INTEGRATED CIRCUITS

ERRATA SHEET

Date: 2008 Nov 07
Document Release: Version 1.3
Device Affected: P89LPC922

Figure 1: Flowchart ICP Global Erase

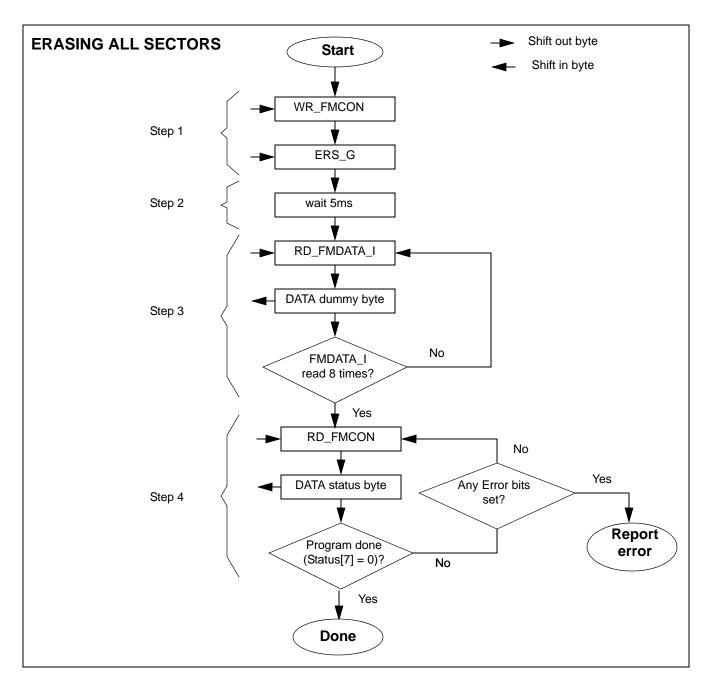
ICP.1: ICP Global Erase

Problem: When giving the Erase Global command through the ICP interface the LPC922 will not clear the

busy flag and stay busy forever.

Workaround: The workaround can be done in 4 steps:

Step 1: Shift out the WR FMCON command followed by the Erase Global opcode.

Step 2: Wait 5ms.

Step 3: Do 8 dummy reads with the RD_FMDATA_I command.

Step 4: Read FMCON until the busy flag gets cleared.

Please also see figure 1 on the following page.
